## Response to the Reviewers' Comments

The authors would like to thank the reviewers for the precious comments and suggestions on the technical contents and presentation of our manuscript “Runtime Power Management of Battery Electric Vehicles for Extended Range with Consideration of Driving Time,” submitted to IEEE Transactions on Very Large Scale Integration (TVLSI.) This revised manuscript has been greatly improved thanks to the reviewers’ invaluable advices. We have revised the manuscript faithfully following the reviewers’s comments. We include the newly added or significantly modified parts in the revised version of the paper also in Response to Reviewers. We highlight the important technical content changes and set those parts in a red color in the revised paper.

Fig. 2: (a) Range-speed experimental data for Chevrolet Bolt [36] and (b) comparison with simulation results of the proposed EV power model.

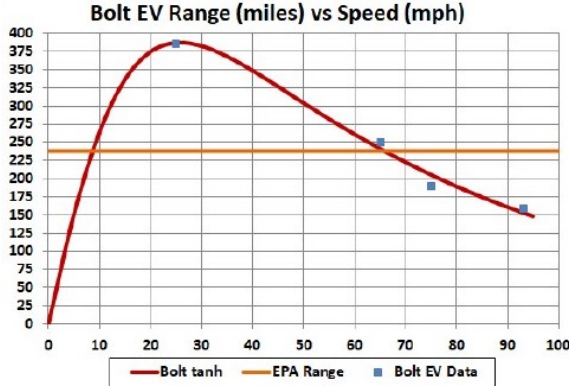
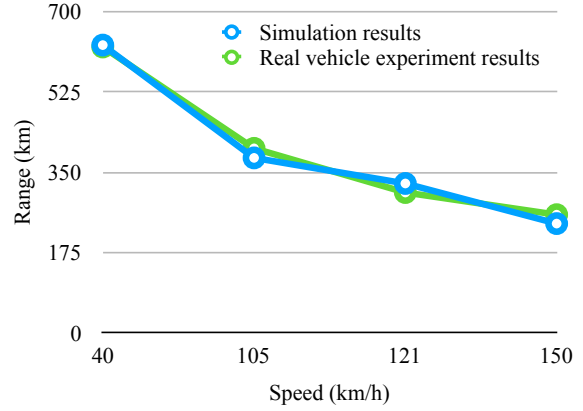
**R1-C2** It is not clear how to validate the power model of EV. As the author mentions that accuracy of power model is quite important, it is good to see the power model in this paper can be validated by some real measurement results.

We further evaluate the model accuracy with the range-speed real vehicle experiments as shown in Fig. 2(a) to confirm the derived power models are close enough to the real vehicle measurement data [32], [33], [34], [35], [36]. We refine the coefficients until all the available data values match well.

As a result, the derived EV power model well matches with the range-speed experimental data as shown in Fig. 2(b) as well as the top speed and maximum acceleration setting the aerodynamic resistance, rolling resistance, curb weight, etc. with the known values. The errors in the range-speed simulation is merely 1.4%, the time for 0-to-100 km/h error is 7.8%, and the top speed error is 3.0%, respectively. We revised the manuscript adding the following paragraph with a new figure in Section III.A on page 3 and 4.

We further evaluate the model accuracy with the range-speed real vehicle experiments as shown in Fig. 2(a) to confirm the derived power models are close enough to the real vehicle measurement data [32], [33], [34], [35], [36]. We refine the coefficients until all the available data values match well.

As a result, the derived EV power model well matches with the range-speed experimental data as shown in Fig. 2(b) as well as the top speed and maximum acceleration setting the aerodynamic resistance, rolling resistance, curb weight, etc. with the known values. The errors in the range-speed simulation is merely 1.4%, the time for 0-to-100 km/h error is 7.8%, and the top speed error is 3.0%, respectively.

Fig. 12: Velocity profile comparison with  $EDP$ ,  $E^2DP$  and  $E^3DP$  on Serrano Avenue in Anaheim Hills.

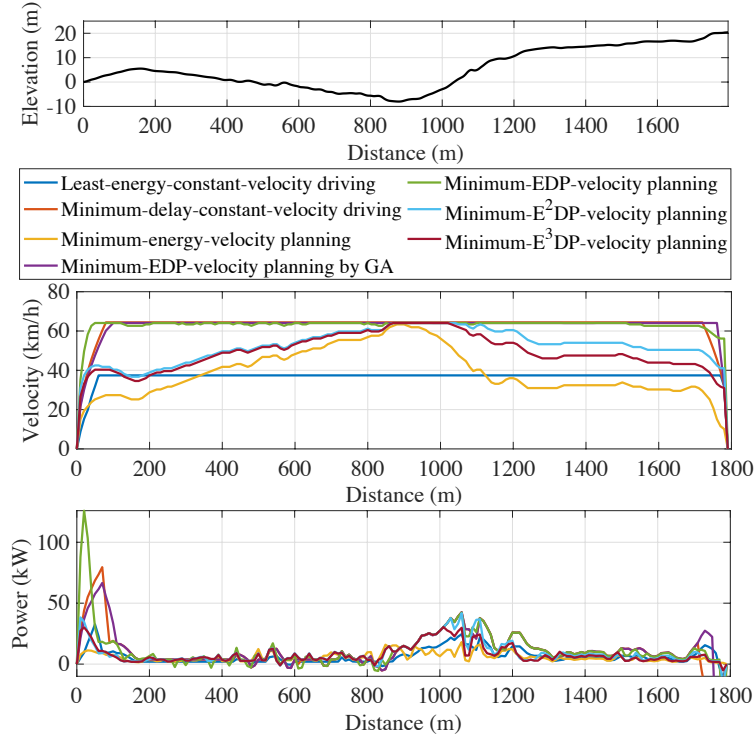
**R1-C3** The optimality of the proposed scheduling algorithm is unclear. The author should add several paragraphs to discuss this topic. It is also to see the comparison baseline is well accepted to show the advantage of the proposed algorithm.

Fig. 13 summarizes  $EDP$  of the least-energy-constant-velocity driving, the minimum-delay-constant-velocity driving, the minimum-energy-velocity planning, the velocity planning with  $EDP$ ,  $E^2DP$  and  $E^3DP$  as a metric on the road benchmarks and the minimum-EDP-velocity planning with GA. The proposed velocity planning results in up to 46.2% improvements of  $EDP$  compared with the least-energy-constant-velocity driving. The driving velocity on a flat road is faster than that of the least-energy-constant-velocity driving at the expense of relatively little energy to save driving time. Then, the velocity decreases when climbing the following uphill to spend less motor torque, which saves more energy.

We also updated Fig. 12 and Fig. 13:

Fig. 11: Histograms of velocity and acceleration for the proposed energy-aware-velocity planning methods without an acceleration constraint (a) and (b) and with an acceleration constraint (c) and (d), respectively.

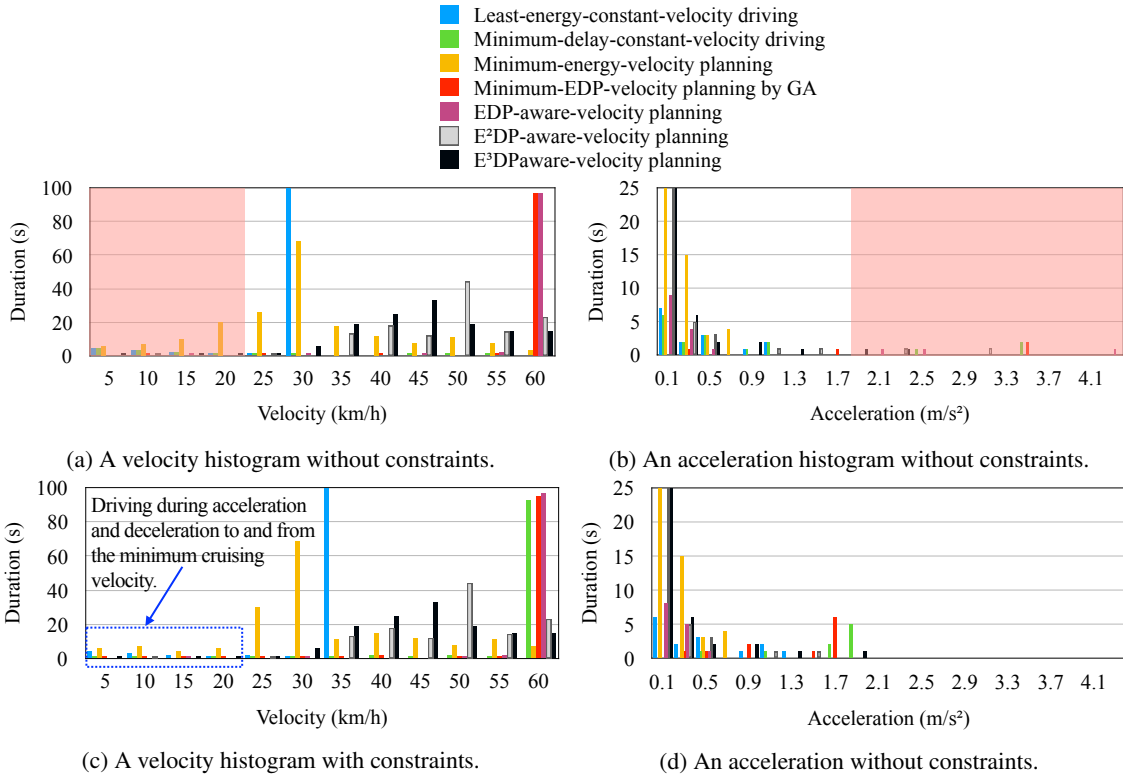
**R2-C2** It would be good to have more discussion on the assumptions of the approach and the experiments, e.g., how much can the velocity be changed in practical scenarios without impeding traffic and causing unsafe situations (also depending on the road conditions and whether it is urban or rural environment I suppose). Currently, there only seems to be one constraint on not slower than 10 km/h.

We quantize the velocity and acceleration values and make a histogram to analyze population of velocity and acceleration for the proposed energy-aware-velocity planning methods. Fig. 11(a) and (b) show two histograms of the driving schemes in Fig. 12, which do not have velocity and acceleration constraints. We avoid a cruising

velocity lower than 25 km/h and an acceleration higher than  $2.0 \text{ m/s}^2$  in this paper without loss of generality. The acceleration of  $2.0 \text{ m/s}^2$  is the same as the maximum acceleration of compact cars designed to be used primarily used in urban areas (13 seconds of 0-to-100 km/h time).

Fig. 11(c) and (d) shows the velocity and acceleration histograms with the constraints. Once we run the DP for the first time without constraints, we analyze the histogram, adaptively determine the minimum cruising velocity and maximum acceleration constraints, and run DP again. We keep the same constraints for online recomputation whenever unexpected interrupts occurs.

Fig. 8: Altitude changes in the real road benchmarks.

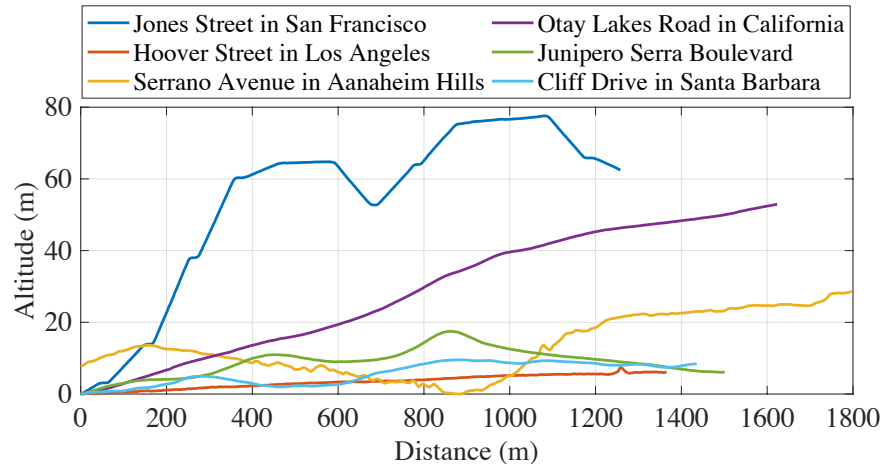
**R2-C3** Related to the last point, it would be good to have more discussion on the road benchmarks, e.g., how they are generated and how representative they are. The optimization results significantly depend on road slope. It would be good to use a variety of real road segments for testing.

**R2-A3** We appreciate the reviewer's comment. We replaced the previous synthetic road benchmarks with the real road benchmarks. We made six new real road benchmarks from various locations in California. The first three roads are in cities. Jones Street in San Francisco and Hoover Street in Los Angeles are two representative city landscapes such as hills and flat roads, respectively, and Cliff Drive in Santa Barbara is a mixture of those. The second two roads are in mountain areas: Serrano Avenue in Anaheim Hills and Otay Lakes Road in San Ysidro Mountain in California. The last road is Junipero Serra Boulevard connecting San Francisco and San Jose. The details of road data is summarized in Table II, and Fig. 8, which visualize the altitudes of the road benchmarks. We also revised all the associated contents with the new real road benchmarks.

We choose six roads from various locations in California and make real road benchmarks. The first three roads are in cities. Jones Street in San Francisco and Hoover Street in Los Angeles are two representative city landscapes such as hills and flat roads, respectively, and Cliff Drive in Santa Barbara is a mixture of those. The second two roads are in mountain areas: Serrano Avenue in Anaheim Hills and Otay Lakes Road in San Ysidro Mountain in California. The last road is Junipero Serra Boulevard connecting San Francisco and San Jose. The details of road data is summarized in Table II, and Fig. 8, which visualize the altitudes of the road benchmarks.
